Sheet: /		File: DMXShield.sch	
Size: A4		Date:	
KiCad E.D.A. kicad 4.0.2-stable		Rev:	
		Id: 1/1

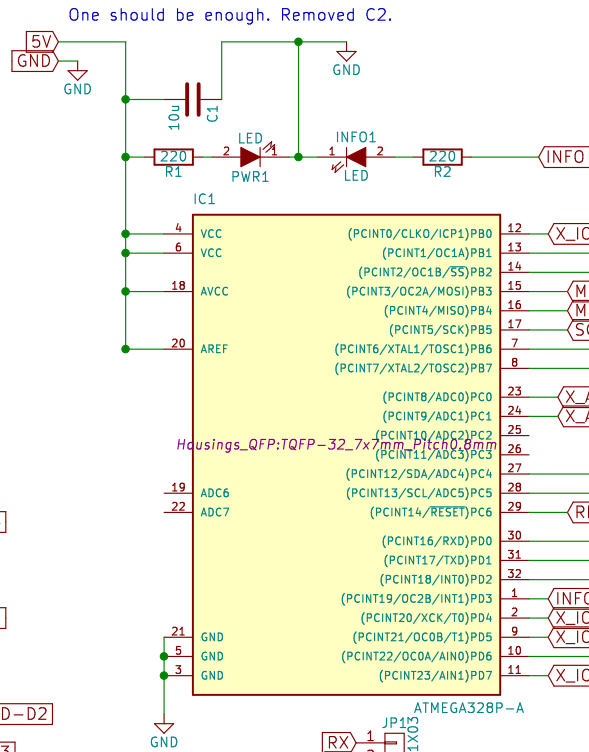
Disconnected 5V
tray to protect
from backflow
via ICSP

One should be enough. Removed C2.

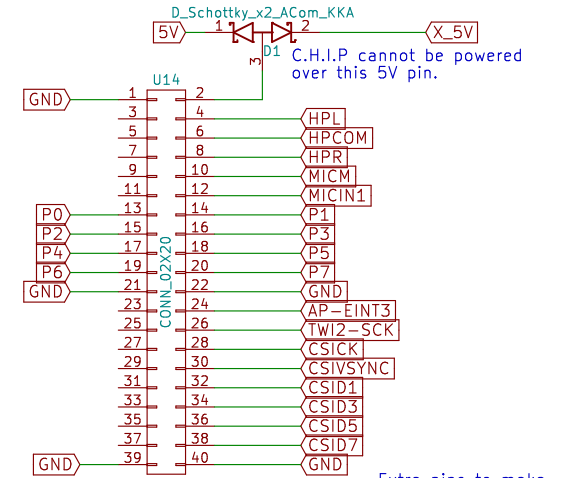
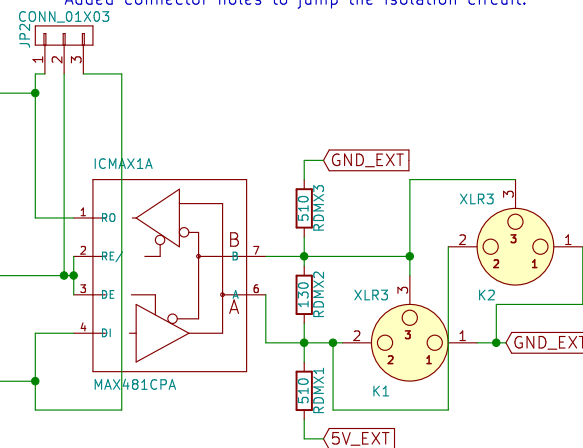
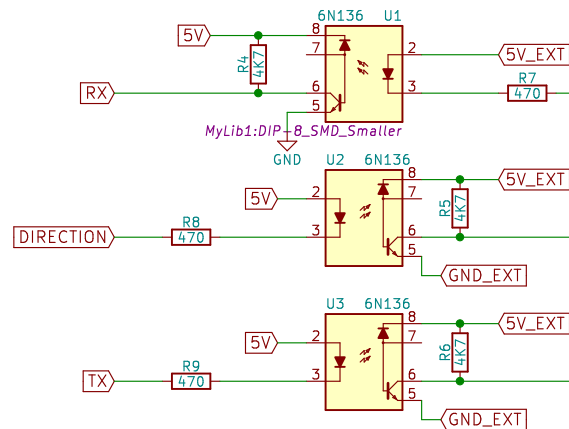
Added connector holes to jump the isolation circuit.

Extra pins to make
use of most of the
atmega. Any ideas?
